PERMIT NO: 22-111973 REV 01

GLADYS SPEERS PUBLIC  
SCHOOL RENOVATIONS  
2150 SAMWAY RD,

<b>BUILDING SERVICES</b>	
<b>REVIEWED</b>	
PERMIT IS ISSUED SUBJECT TO ANY REASON SHOWN IN COLOUR AND MARKED THEREON OR ON ATTACHE DOCUMENT.	
PERMIT NO:	22-111973R1
DATE:	Sep.24, 2024
REVIEWED BY:	N. Varias
CONSTRUCTION MUST CONFORM TO THE ONTARIO BUILDING CODE

ENLARGED  
LIBRARY 22 PLAN

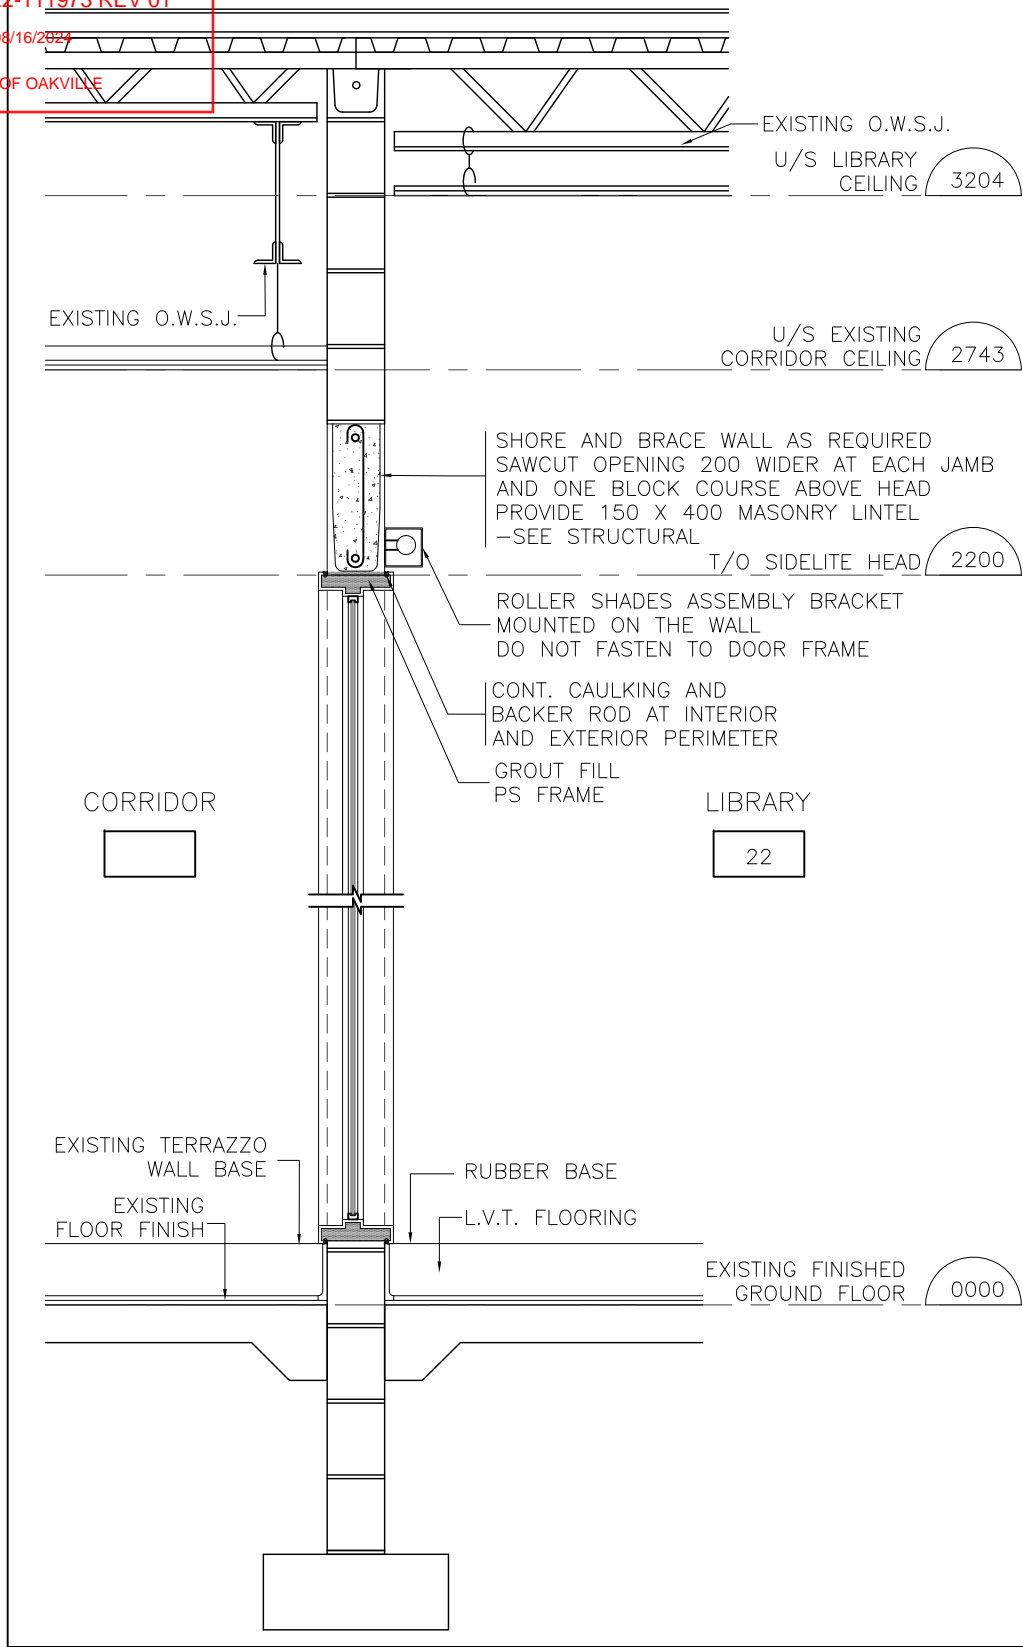
## 1hr FRR Fire Separation

3/4hr FPR door &  
frame c/w closer

Max. 60 persons occupant load to be posted
